1445 NEW YORK AVENUE NW

PROPOSED RENOVATIONS

COMMISSION OF FINE ARTS

CONCEPT REVIEW SUBMISSION

CFA1 COMMISSION CONCERNS

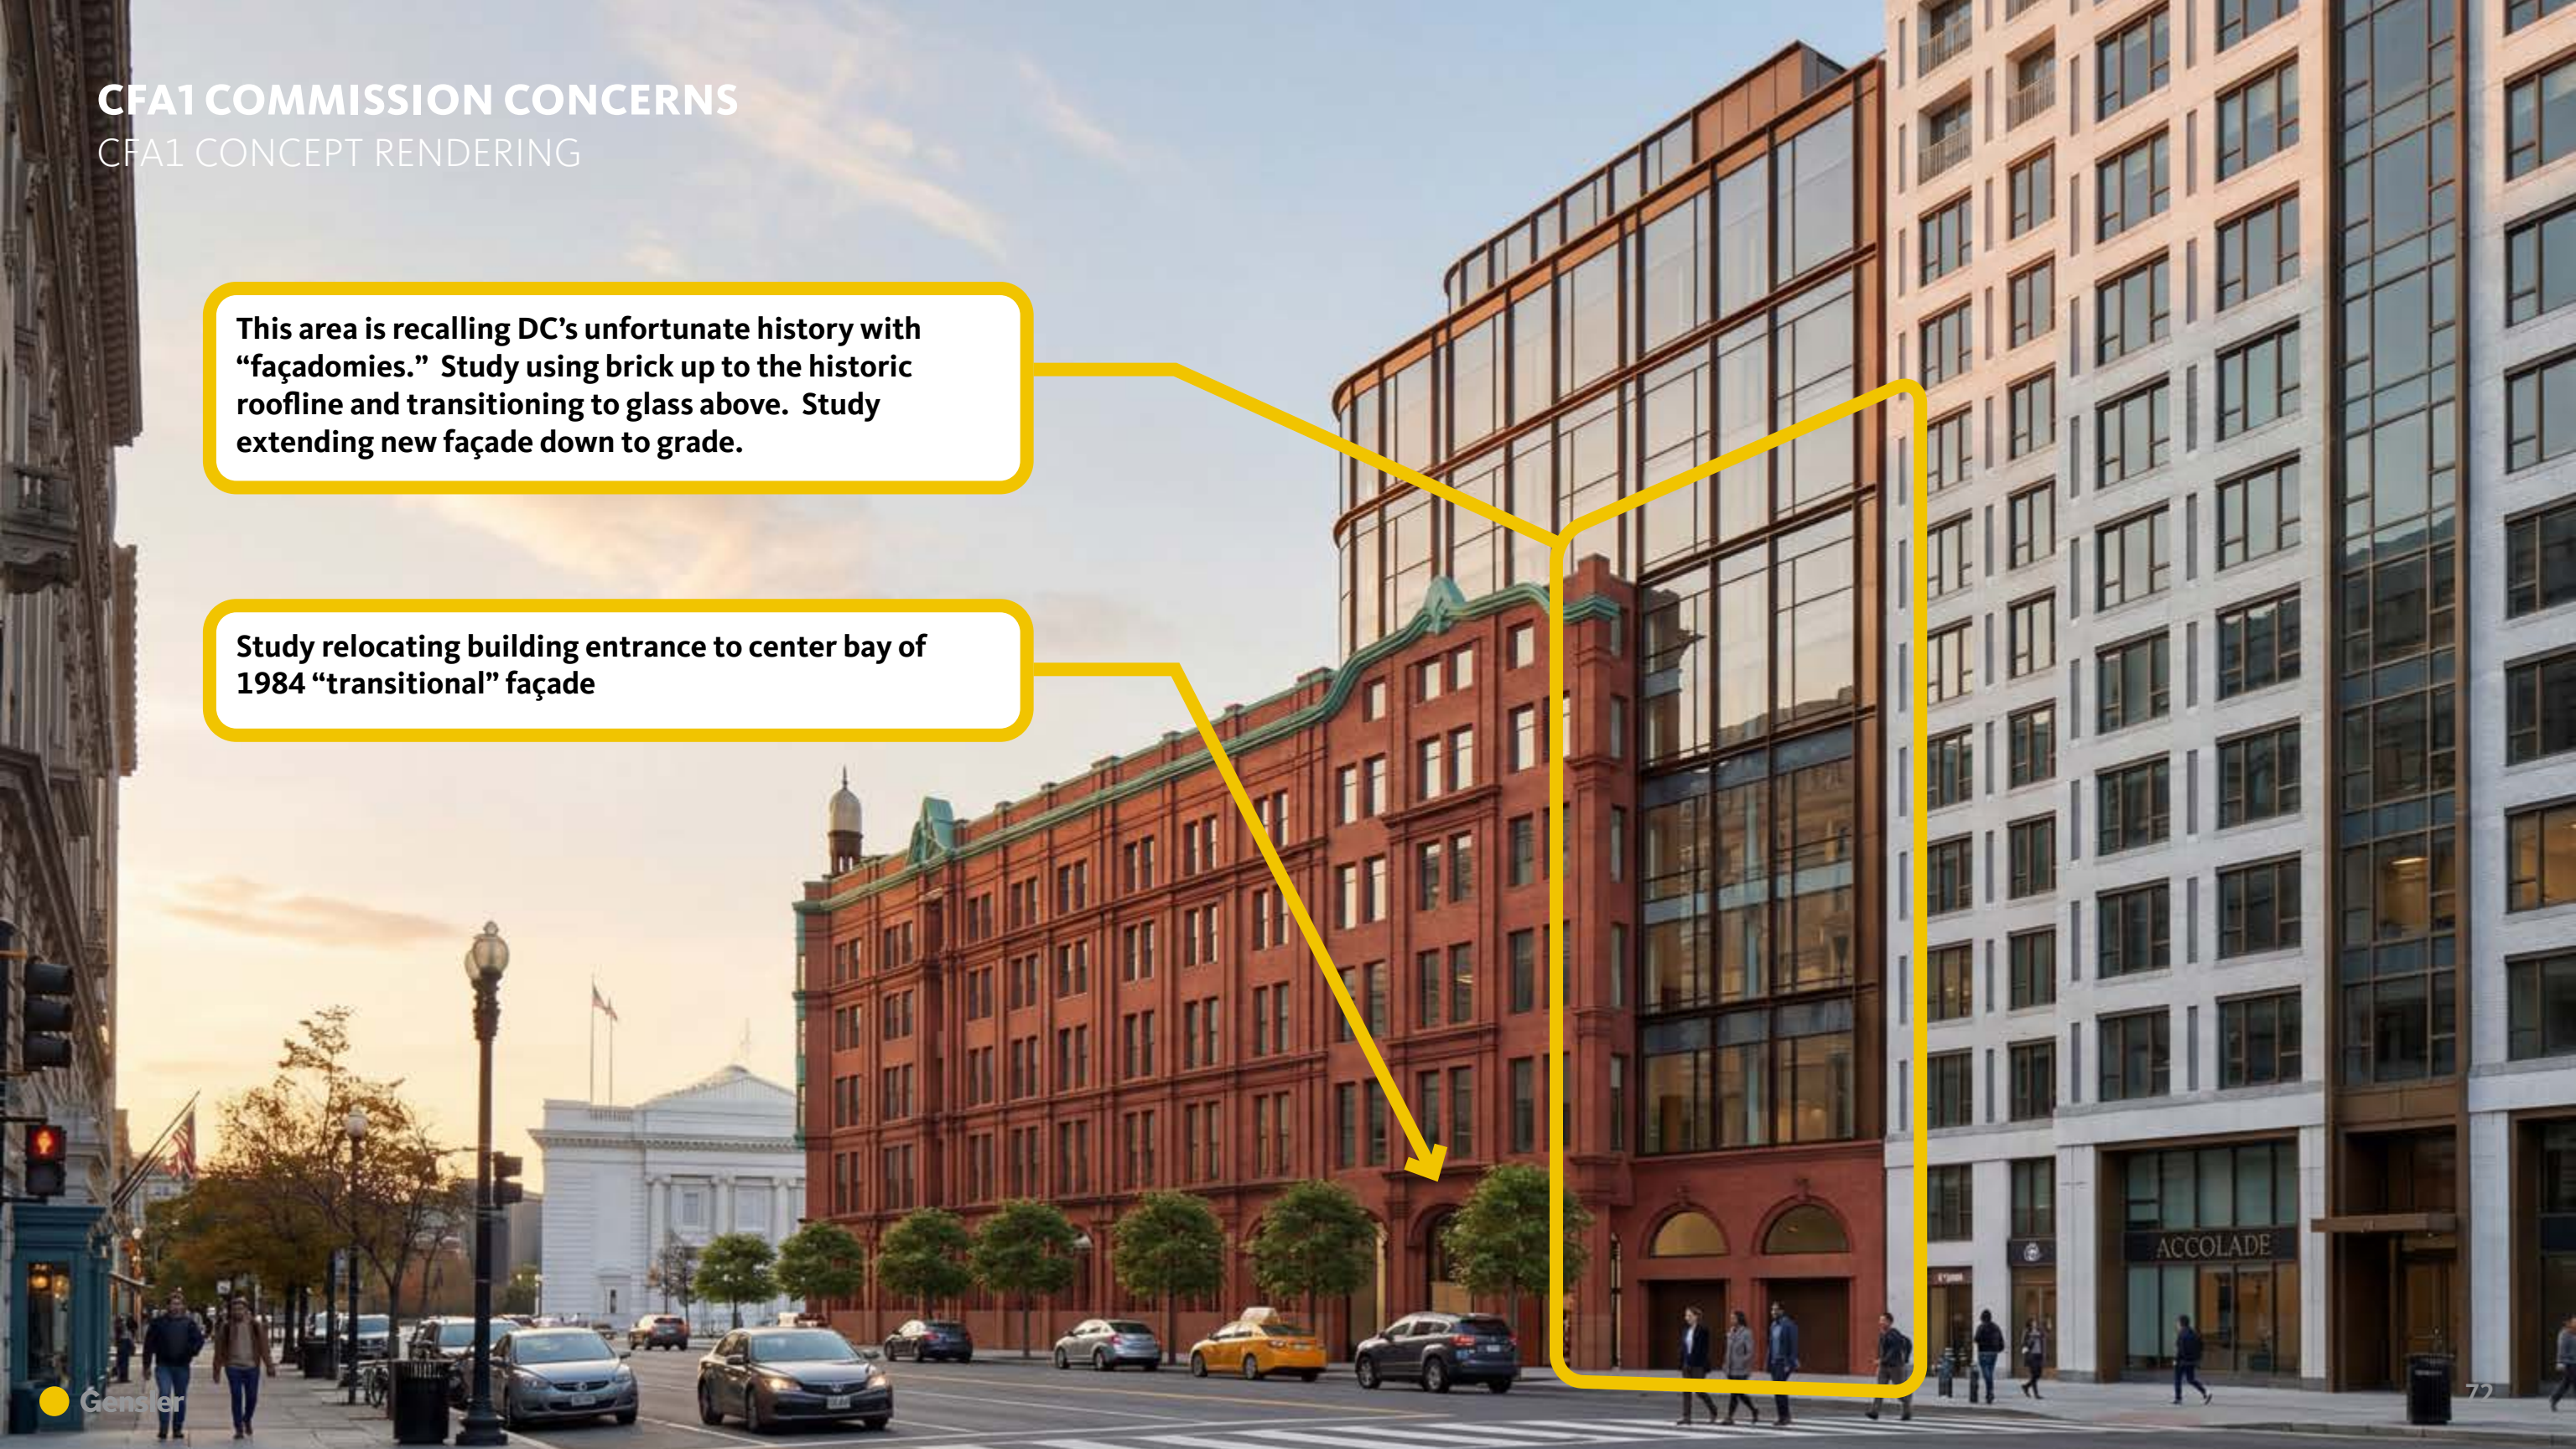
This area is recalling DC's unfortunate history with "façadomies." Study using brick up to the historic roofline and transitioning to glass above. Study extending new façade down to grade.

Study relocating building entrance to center bay of 1984 "transitional" façade

CFA1 COMMISSION CONCERNS

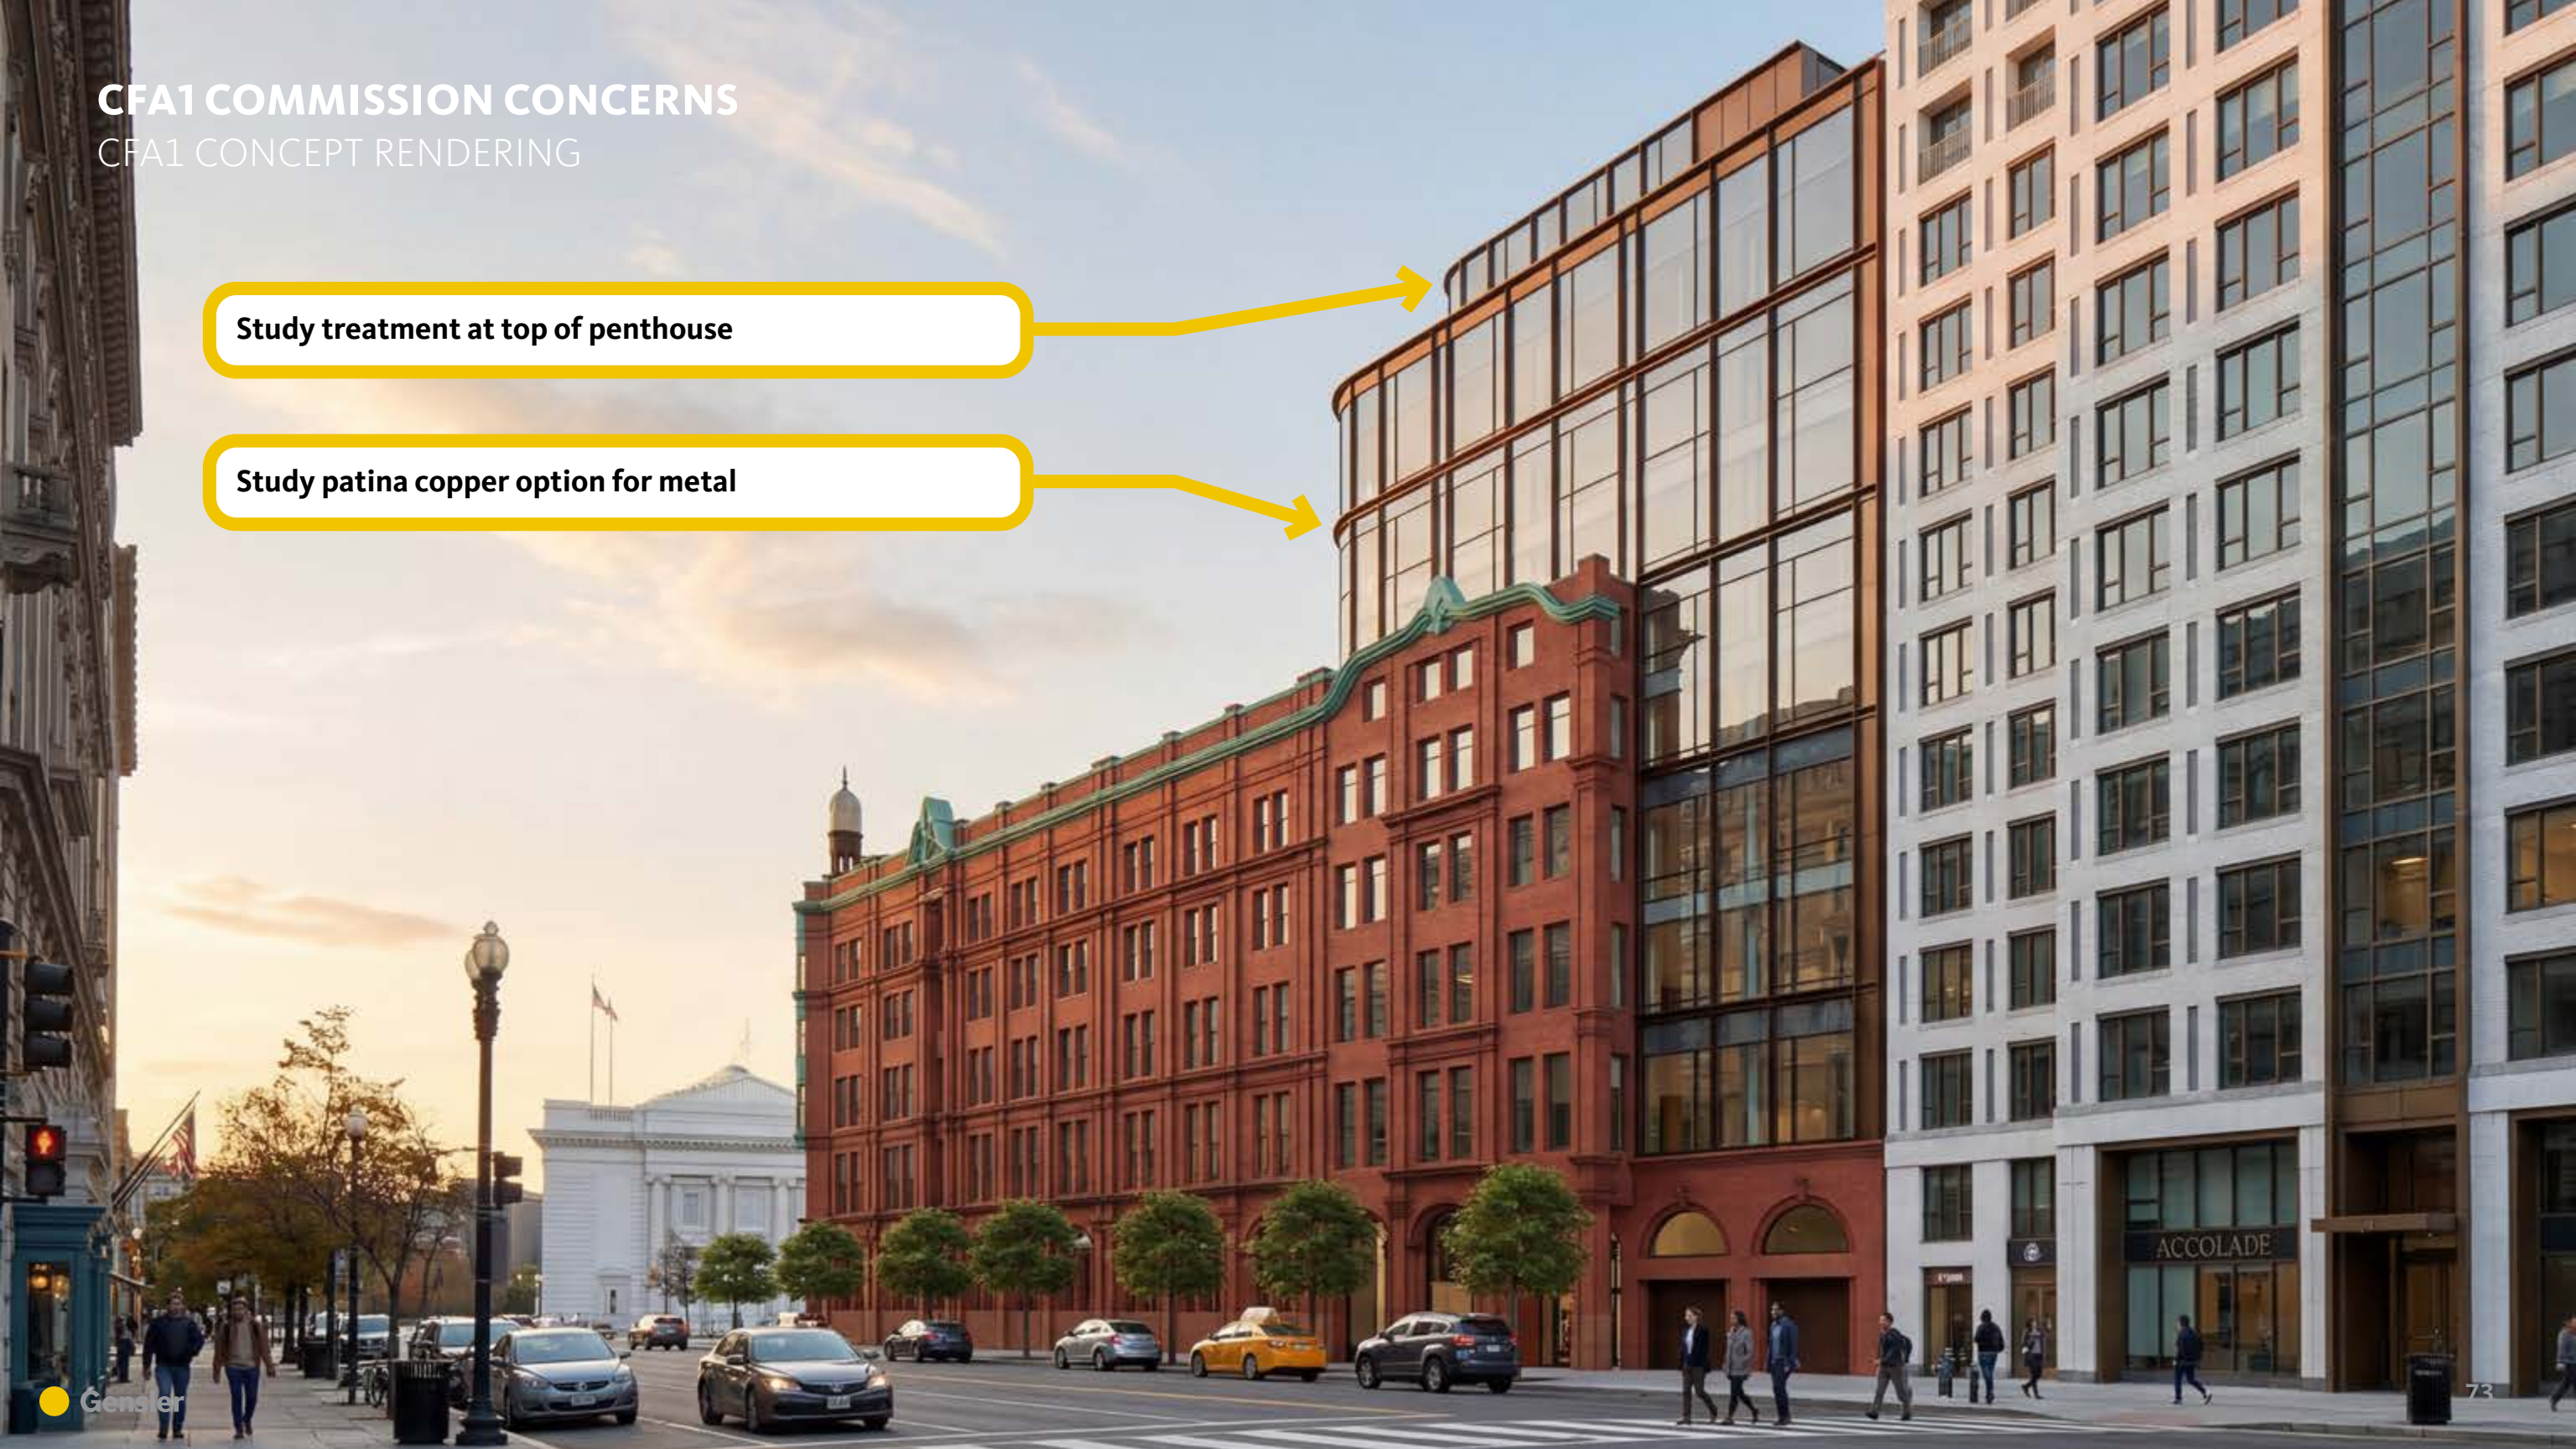
Study treatment at top of penthouse

Study patina copper option for metal
